In the matter of
Pacific Gas and Electric Company
Diablo Canyon Nuclear Power Plant
Units 1 and 2

Docket Nos. 50-275-LR
50-323-LR

DECLARATION OF PETER BIRD, Ph.D

Submitted to the U.S. Nuclear Regulatory Commission
By San Luis Obispo Mothers for Peace, Friends of the Earth,
and Environmental Working Group

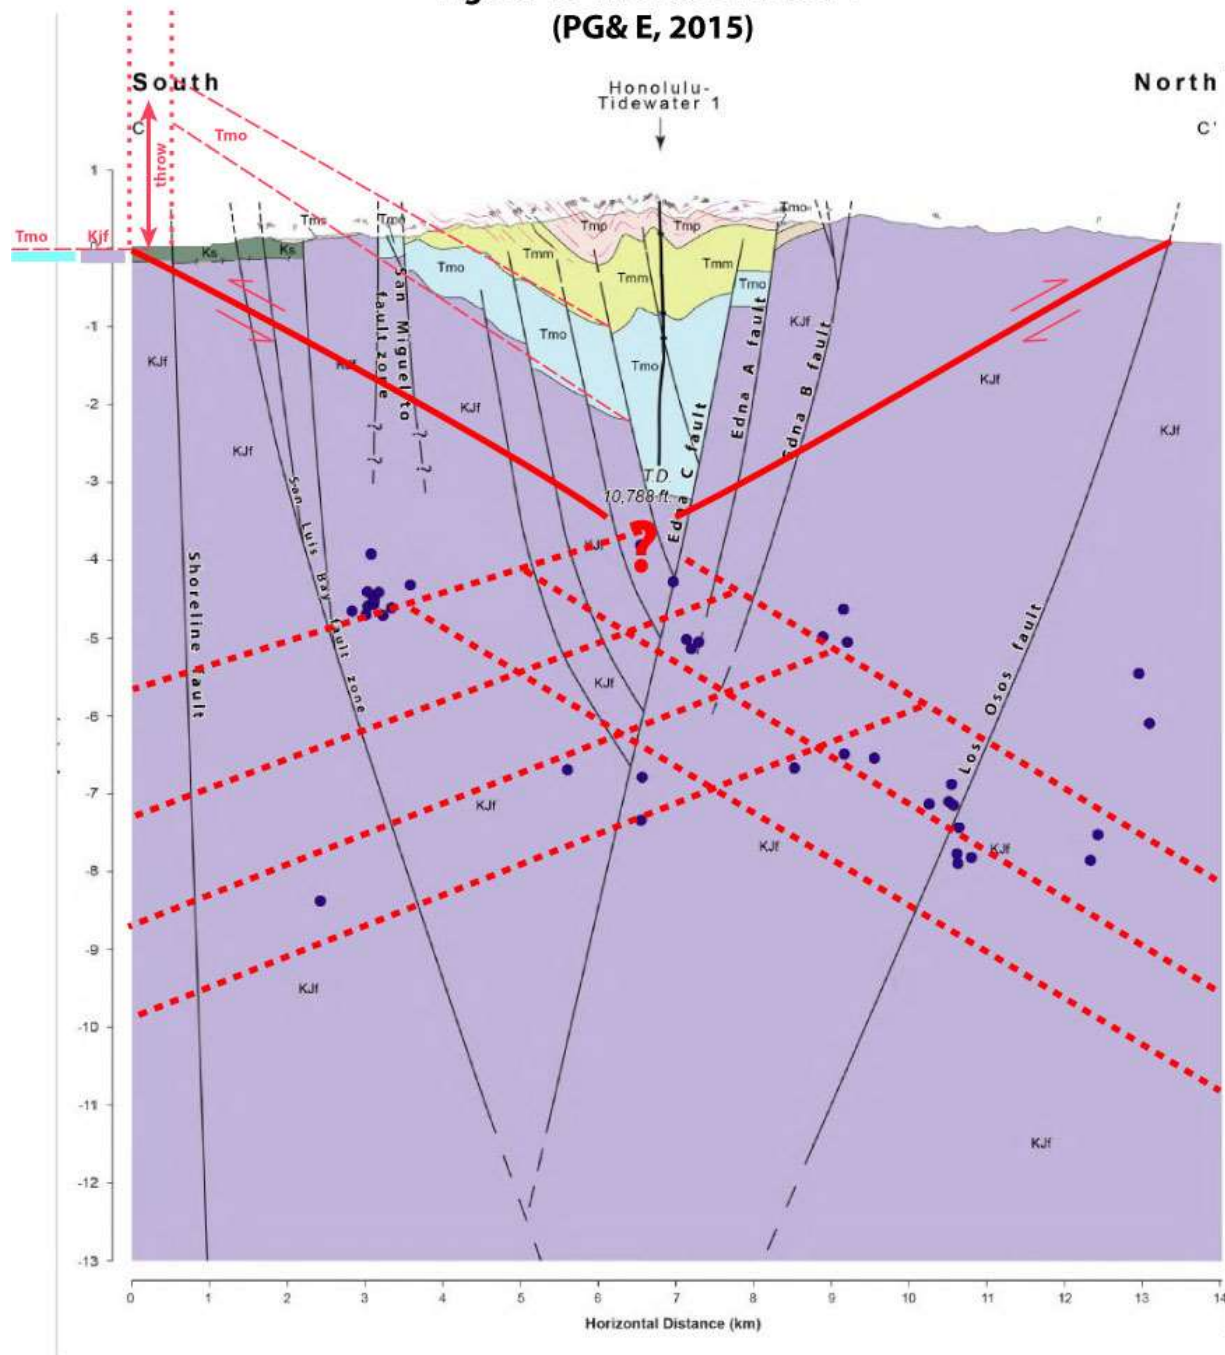
- b. According to the geologic map [PG&E, 2014] and associated cross-section C-C’ in its Fig. 13-17, the apparent throw (vertical offset) of stratigraphic unit Tmo Obispo Formation is 1.6~2.2 km across the Shoreline fault trace. (This measurement is illustrated in my own Figure 1.) None of this can be explained by strike-slip on the Shoreline fault because its slip-rate is very low and because regional strikes of bedding are roughly parallel to it. Instead, the simplest explanation is thrust-faulting on the Inferred Coastline thrust that shares the complex, braided surface trace of the Shoreline fault. Assuming a typical thrust-fault dip of 25°, the amount of slip required to create this throw is $(1.6\sim 2.2 \text{ km}) / \sin(25^\circ) = 3.8\sim 5.2 \text{ km}$. Then, assuming this occurred since ~5 Ma, the mean rate of slip on the Inferred Coastline thrust has been 0.76~1.04 mm/a. To the northwest of section C-C’ the throw of unit Tmo becomes much less, but the area of neotectonic uplift of the Irish Hills (Figure 7-4 in PG&E, 2015) continues to the northwest; so there the thrust fault probably does not terminate but merely deforms unit Tmo into a fault-initiation anticline above it. (In this area, complex older deformation associated with intrusions of Tmod diabase obscures the Pliocene-Quaternary structure, and makes balanced-section methods inapplicable.) In my professional judgment, this Inferred Coastline thrust fault continues, with the same rake and offset, northwest to the Hosgri fault.

**Mark-up (in red) by P. Bird, 2023 of
Figure 13-17 of SSC for DCP
(PG&E, 2015)**
